DART SERVICE INSTRUCTION

TO AMEND INSTALLATION INSTRUCTIONS IIN-D058-676 REV. A AND
INSTRUCTIONS FOR CONTINUED AIRWORTHINESS ICA-D058-676 REV. 0
REF: FAA STC: SR01018SE

A	NEW ISSUE		RF	08.11.06
REV.	DESCRIPTION		BY	DATE
DESIGN	RF	DART AEROSPACE USA, INC.		
DRAWN	RF	PORT HADLOCK, WA		
CHECKED	DS	DRAWING NO.	REV. A	
MFG. APPR.	N/A	DSI 9425	SHEET 1 OF 2	
APPROVED	DS	TITLE	SCALE	
DE APPR.	<i>MM</i>	CROSSTUBE SUPPORT CHANGE	NTS	
DATE	08.11.06	COPYRIGHT © 2008 BY DART AEROSPACE USA, INC. THIS DOCUMENT IS PRIVATE AND CONFIDENTIAL AND IS SUPPLIED ON THE EXPRESS CONDITION THAT IT IS NOT TO BE USED FOR ANY PURPOSE OR COPIED OR COMMUNICATED TO ANY OTHER PERSON WITHOUT WRITTEN PERMISSION FROM DART AEROSPACE USA, INC.

FIGURE 1 - CROSSTUBE SUPPORT

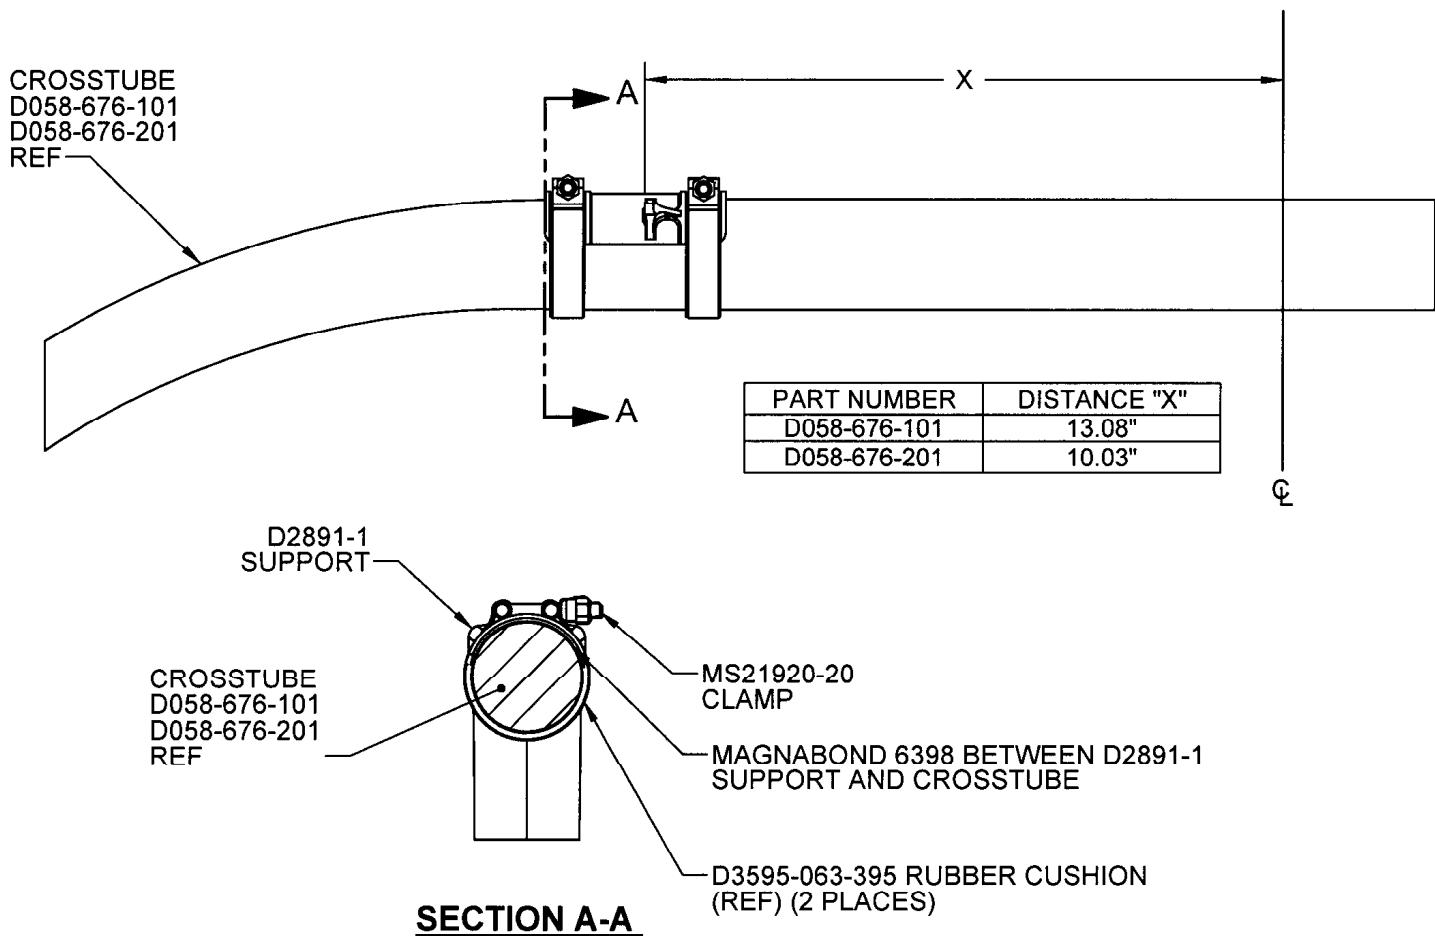
For D058-676-101/-201 crosstubes at CHG 002 or later, the D2856-400-694 abrasion strips have been removed, the D2891-1 supports have been bonded onto the crosstube using Magnabond 6398 and D3595-063-395 Rubber Cushions have been installed underneath the MS21920-20 Clamps. Amend parts list of the IIN-D058-676 Section 5 and ICA-D058-676 Section 32.8 as follows:

To prevent the supports from shifting on the D058-676-101/-201 crosstubes at CHG 001, the D2891-1 supports should be removed and re-installed as follows:

- 6) Apply a 0.03" to 0.06" thick layer of Magnabond 6398 underneath each D2891-1 support and re-install the support on the crosstube as shown in Figure 1. Position and secure the D2891-1 supports on the crosstube using MS21920-20 Clamps. Install a D3595-063-395 Rubber cushion underneath each MS21920-20 Clamp. Torque clamps 80-100 in-lb. Let the D058-676-101/-201 crosstube assembly cure as per the Magnabond 6398 instructions before re-installing the crosstube on the aircraft.
